**Kenneth McCormick
790 Fairfield Circle
Pasadena, California 91106**

October 23, 2017

Subject: Geotechnical Engineering Opinion on Documentation Provided
800 Fairfield Circle, Pasadena

800 Fairfield Circle Permit Requests & Zoning Appeals Timeline
SUBMITTED BY AVRAM GOLD

NOTICE OF FIELD OBSERVATION

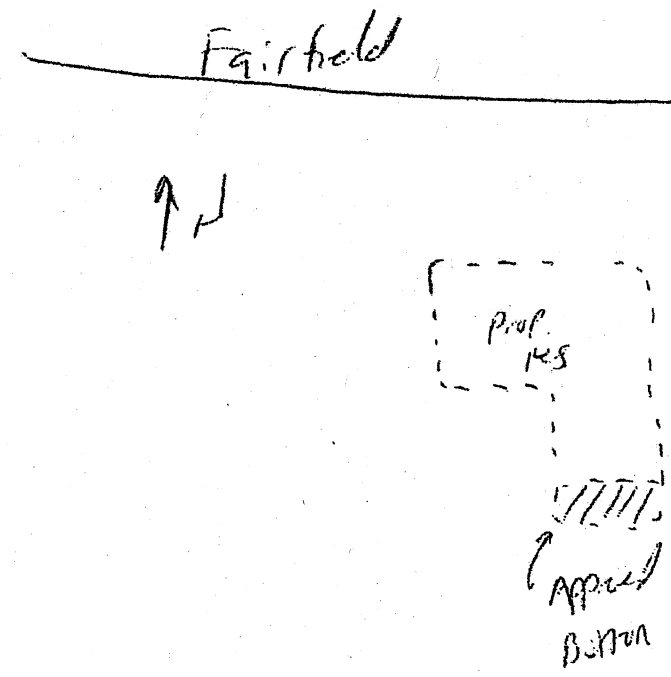
Field Memorandum, April 5, 2016 – Geotechnical Field Technician noted that dense terrace soils were exposed over 3/4 of building footprint, but that a smaller area (“downhill 1/4”) had thin fill and soil (noted to be only 2 feet thick in next visit). Technician recommended *“Remove all fill and soil in areas of slab and hardscape. Expose dense soil and call for bottom inspection.”*

Based on these two field memorandums, there is no mention of an excavation being required deeper than 2 feet to remove existing fill soils that extended below the planned finished subgrade. This would indicate that the dense terrace deposits were exposed over ¾ of the building footprint to support footings as planned, and that over ¼ of the building footprint the footings would be supported on up to 2 feet of compacted fill or extend up to 2 feet deeper to reach into the terrace materials.

IRVINE GEOTECHNICAL
NOTICE OF FIELD OBSERVATION

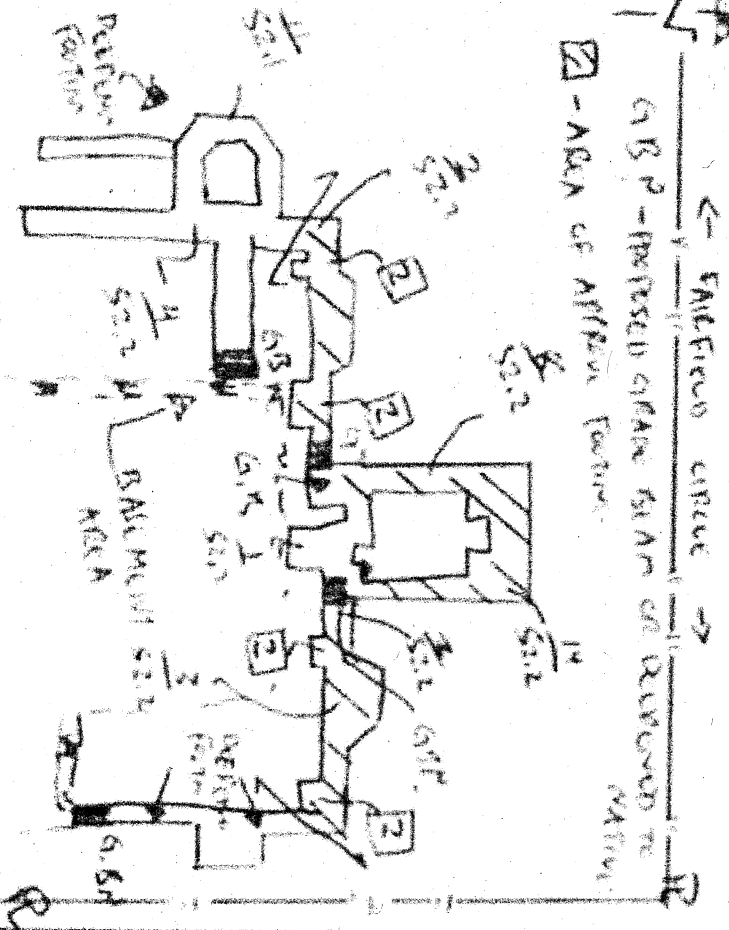
Field Memorandum, September 28, 2016 – It appears that the scope of the project changed between the April and September field memorandums. In April, a very limited amount of work (remove and recompact 2 feet of soil over ¼ of the building pad) was recommended by the Project Geotechnical Engineer and subsequently performed. In September, the field memo references basement walls, deepened footings, and grade beams. We noted the following after reading this document:

- The field report references basement walls when referring to the footings observed.
- The report references compacted fill soils and native soils being exposed in the footing excavations, and follows by stating that *“It is recommended to either place a grade beam*

or deepen to native soils." It is not clear if this is a deviation from the project geotechnical investigation report. If so, it is a recommendation that should have been made by a registered engineer and not a technician or inspector. It is unclear if the field report was written by an engineer.

- In reading the daily report, it appears that the recommendation is to support footings in native soils only. As a result, the report recommends "a grade beam", which would span over the fill soils and be supported on each end by a footing supported in the native soils (this is a structural alternative that would require the project structural engineer), or "deepened to native soils." Deepening to native soils involves simply deepening the footing excavation to extend through the fill soils and embed into the native soils. Typically, this deepened portion of the footing excavation is backfilled with concrete to the designed base of footings, and then the footings are constructed as designed.

- Deepening a footing does not require removal of all of the in-place fill soils, but instead removing only the fill soils beneath the footing. The concrete used to backfill the deepened portion has sufficient strength to carry the structural bearing loads down to the native soils so that the fill soils left in place are not loaded.

- If the fill soils were removed in their entirety, which is not consistent with the field report, the process would simply involve excavating the soils to expose the native soils (as noted in the April 2016 field memos), backfilling the materials in lifts to properly compact, and then re-excavating the footings as designed. This process would not involve placing a concrete slab, and given the information available, we are not aware of a reason why a concrete slab at depth would be required as part of a foundation system.

Irvine Geotechnical 9/28/16 SITE REPORT for foundation footings

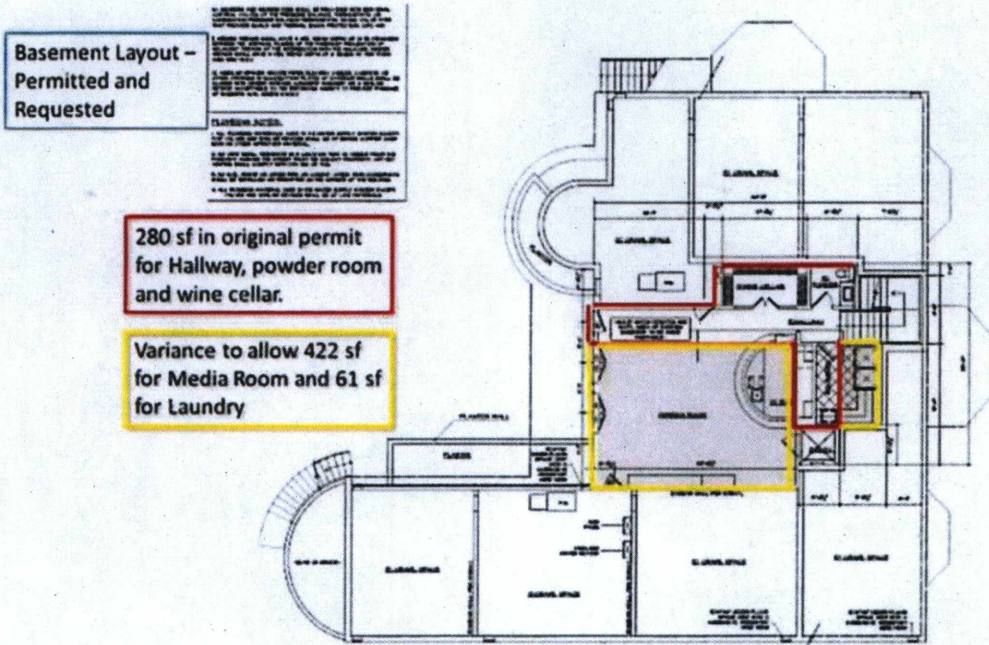
9/28/16 - Irvine Geotechnical writes up forth SITE REPORT for first floor footings and pads: "Arrived on site as requested for the first floor footing observation. There is a couple of issues with the footings. Portion of footings that are perpendicular to basement walls are in compacted fill, the rest of the footings sit in native soils. It is recommended to either place a grade beam or deepened to native soils. The footings to the north are embedded into native soils per approved soils report. The footings have been excavated to the width and depths, per plan."

This 4th field observation report does not address any backfills as prescribed by the covenant. On the contrary, the sketch of the field conditions still shows proposed expanded basement area that would be asked for later. See sketch below and the dotted line for the basement area, and then the 9/7/2017 Board of Zoning Appeals variance request for the 422 sq/ft media room.
